response to DRMS TR10 preliminary adequacy review letter for Holcim (US) Inc. Portland, CO Plant

Response to DRMS Technical Revision (TR-10) Preliminary Adequacy Review
Holcim (US) Inc. Portland, Colorado Limestone Quarry, Permit No. M-1977-344

November 19, 2014

Figure 6. MW-7 Well Completion, Depth to Groundwater, and Water Quality

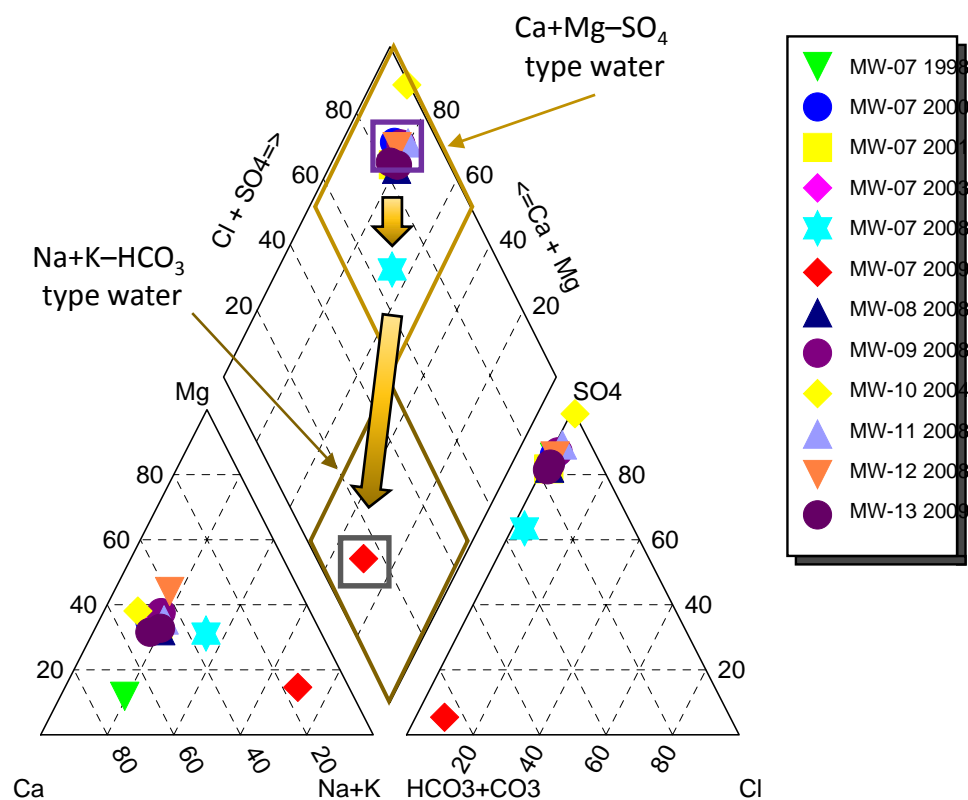
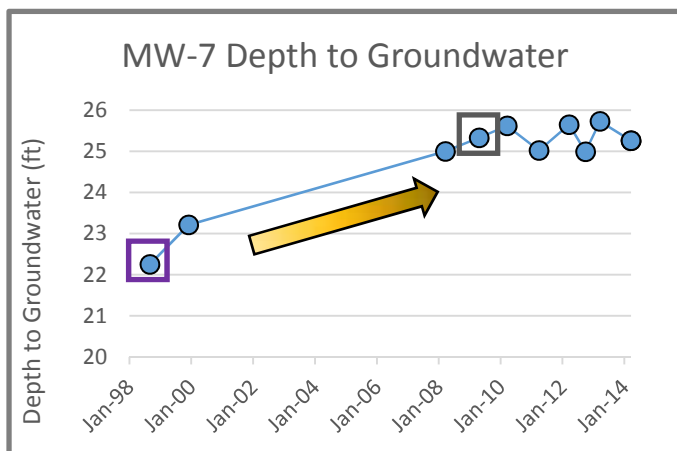
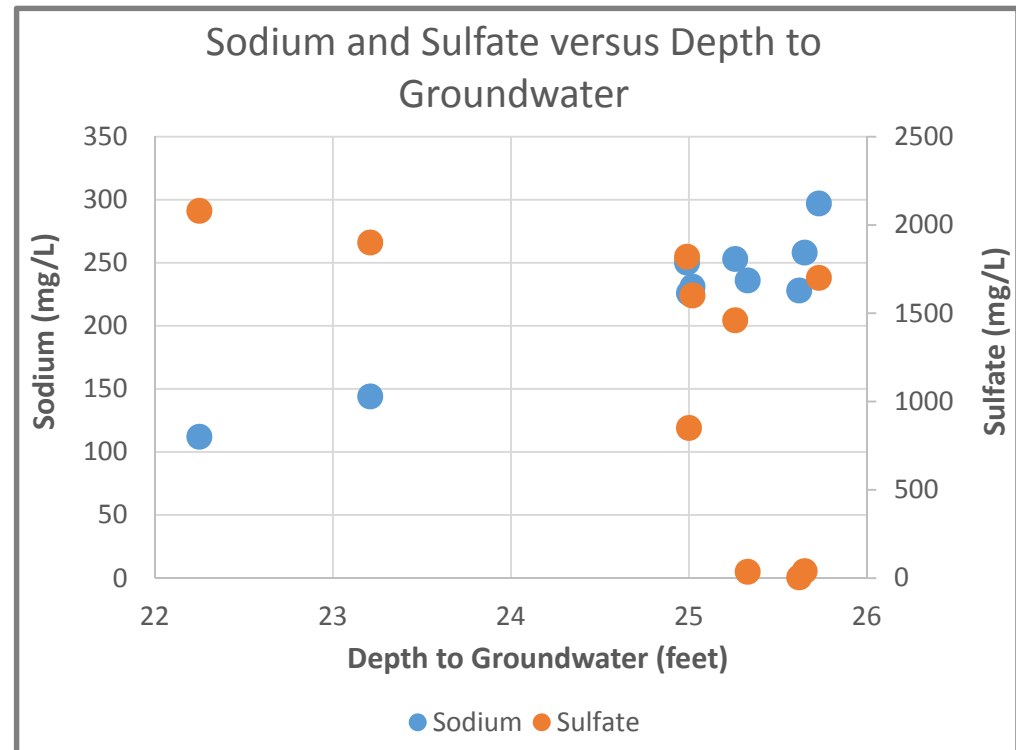
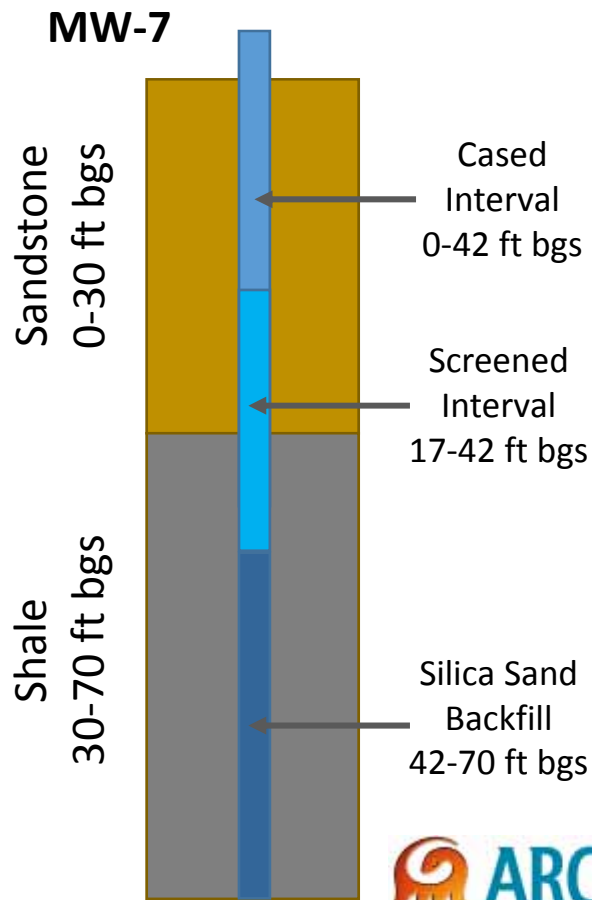
MW-7 is completed within the Codell Sandstone and the underlying Blue Hill Shale. The MW-7 borehole was completed to a total depth of 70 feet below ground surface (ft bgs) with the upper 30 feet in the sandstone and the lower 40 feet in the underlying shale (**Figure 6**). The borehole was backfilled with silica sand to a depth of 42 ft bgs. The borehole was cased and a slotted screen interval was completed from 17 to 42 feet bgs across both the sandstone and shale bedrock. When the depth to groundwater increases at MW-7, the proportion of groundwater that may be contributed from the shale increases and may result in the observed shifts in groundwater quality with increased depth to groundwater. No other site groundwater monitoring wells intersect the Blue Hill Shale and no other site groundwater monitoring wells exhibit the wide variability in constituent concentrations observed at MW-7. The borehole log is included as Attachment 1 to this letter.

- MW-7 completed within sandstone and shale bedrock
- Greater contribution of water from shale with greater depth to groundwater
- Groundwater in shale may have different composition than in overlying sandstone
